21 August 2026
BMC26068: 47 Primrose Street, Sherwood

RE: 47 Primrose Street, Sherwood
Traffic Engineering Response to Information Request
Brisbane City Council Application Reference: A007059364

I refer to the Planning Application lodged over land located at 47 Primrose Street, Sherwood and Brisbane City Council's (BCC's) Information Request, dated 4 August 2026. The following has been prepared to address Items 1 – 4 of the Information Request, which are reproduced and responded to below.

10.235m Rear-Load Refuse Vehicle: Entry
BCC Std Dwg BSD-3008

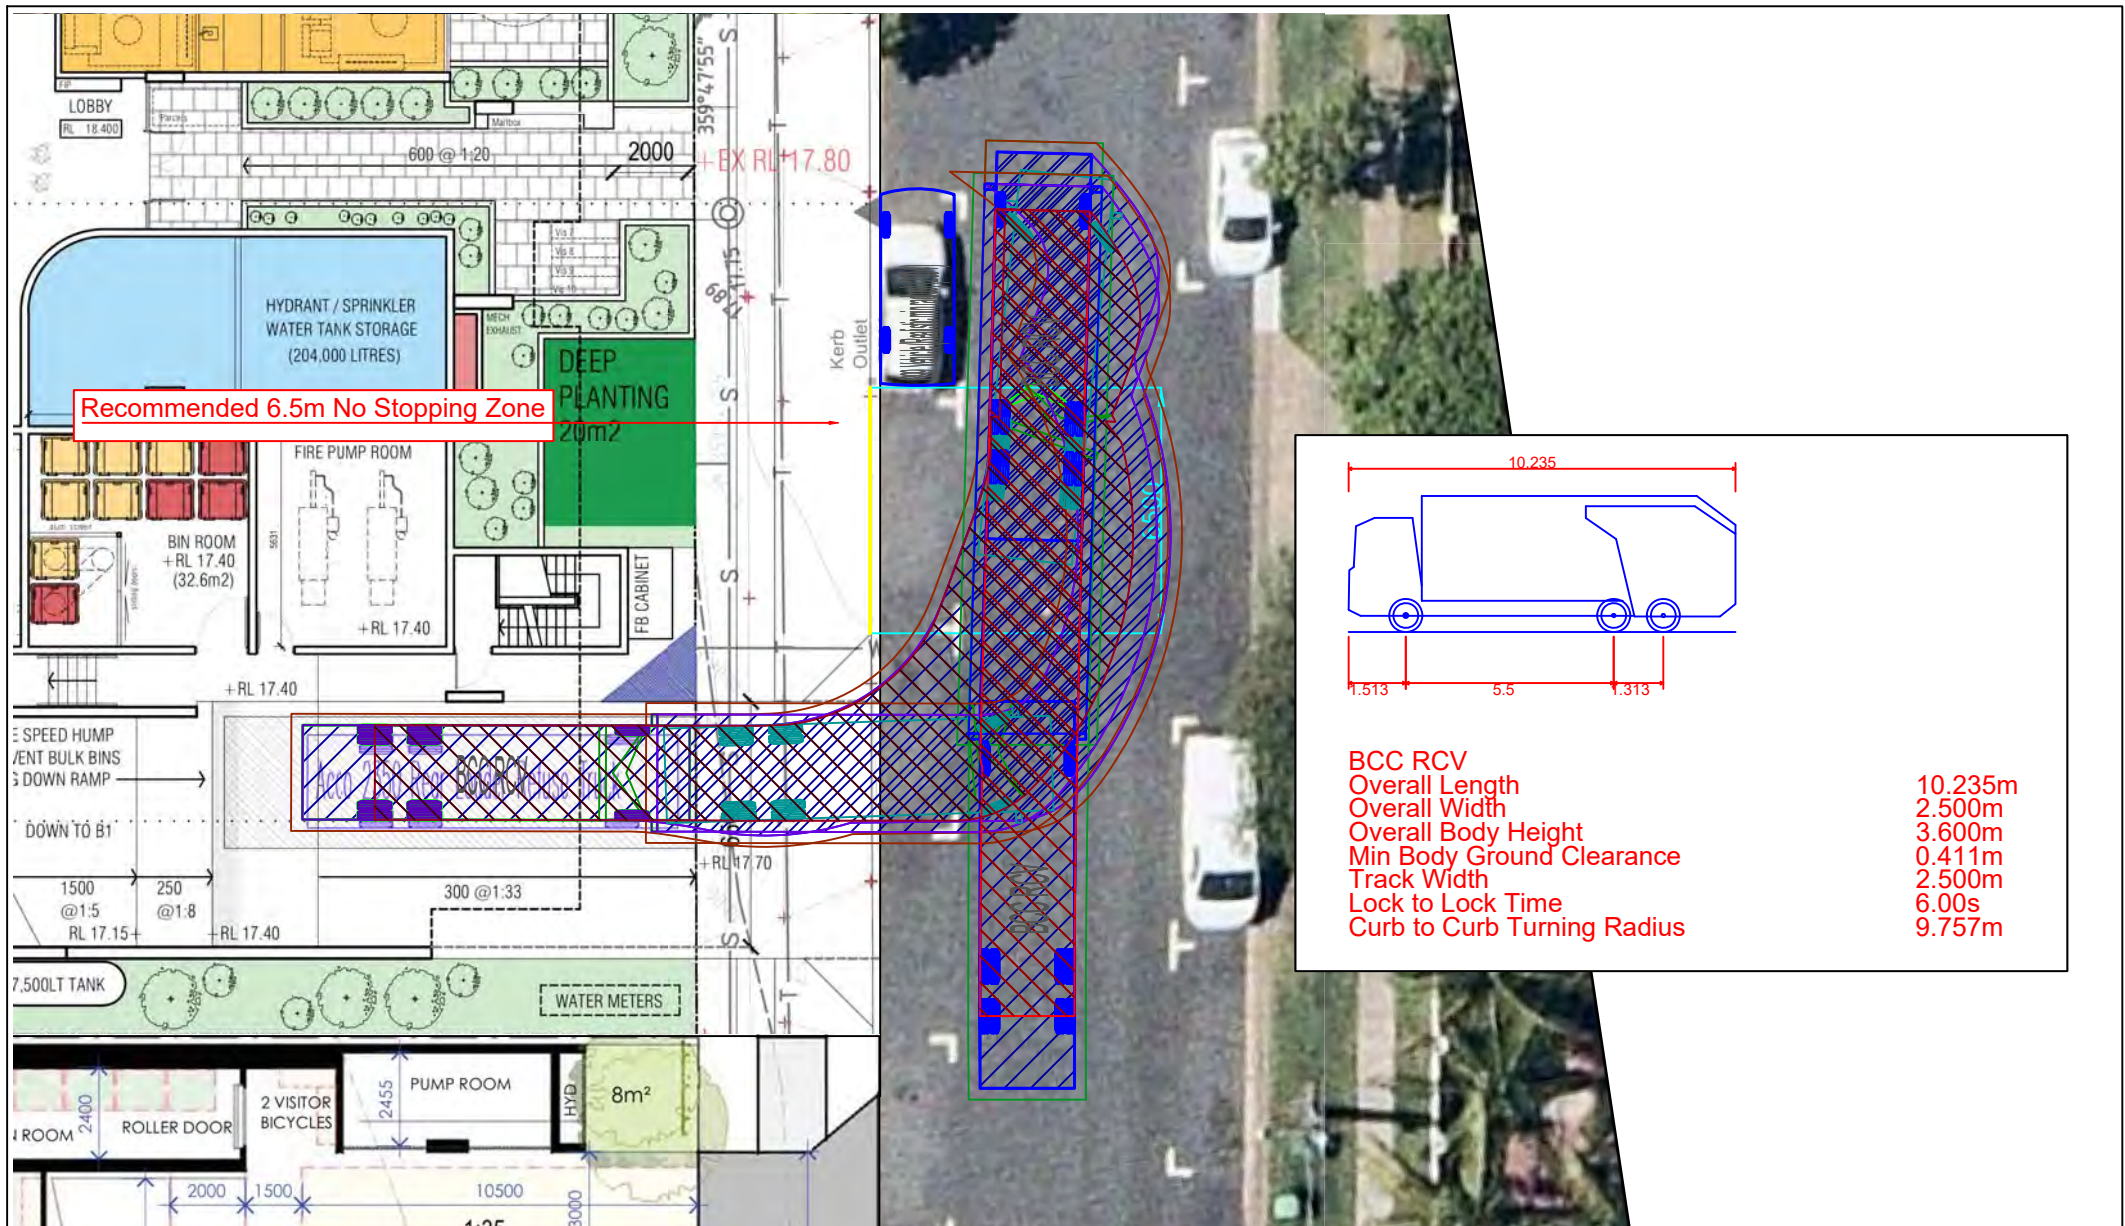
The submitted BMC Traffic – 10.235m Rear-Load Refuse Vehicle: Entry & Exit manoeuvres do not demonstrate that safe and efficient servicing can be undertaken while a lawfully parked vehicle is parked within the delineated on-street parking space north of the driveway wing taper.

- a. Utilising amended architectural plans, submit revised RPEQ-certified swept path analysis for a 10.24m Rear Loading RCV (As per BSD-3008-2) as specified within Table 3 of the Refuse planning scheme policy (RPSP) which demonstrates safe and efficient entry and exit manoeuvres can be undertaken whilst utilising a lock to- lock time of 6.00s, curb-to-curb-turning radius of 9.757m and whilst a lawfully parked vehicle is parked within the delineated on-street parking space to the north of the proposes driveway crossover wing taper.*

- b. Ensure the swept path for all vehicles demonstrates a 6.5m wide driveway crossover with Type B2 wing tapers and delineated on-street parking spaces as denoted on the submitted Site Plan.*

Updated swept path assessments are provided at Attachment B to this advice. These assessments include the following, demonstrated with a 6.8m wide Type B1 crossover:

- A 10.235m long rear loading RCV (which is the length as per BSD-3008-2) accessing the site, with the associated requirements for turning radius and lock-to-lock time, as shown in the drawings.
- A 12.5m Heavy Rigid Vehicle, as per the Australian Standard AS/NZS2890.2:2002 accessing the site.
- A B99 passenger car passing the 10.235m RCV and 12.5m HRV whilst loading.

It is recommended to install yellow line marking, as shown, for a length of 6.5m to the north of the driveway.

Please see the above. The swept paths have been undertaken on the basis of a 6.8m wide crossover with a Type B1 crossover flare. The swept paths indicate that a Type B2 crossover flare is not required to achieve accessibility. A Type B2 splay is not proposed, to enable the crossover flare to remain in front of the projection of the property boundary.
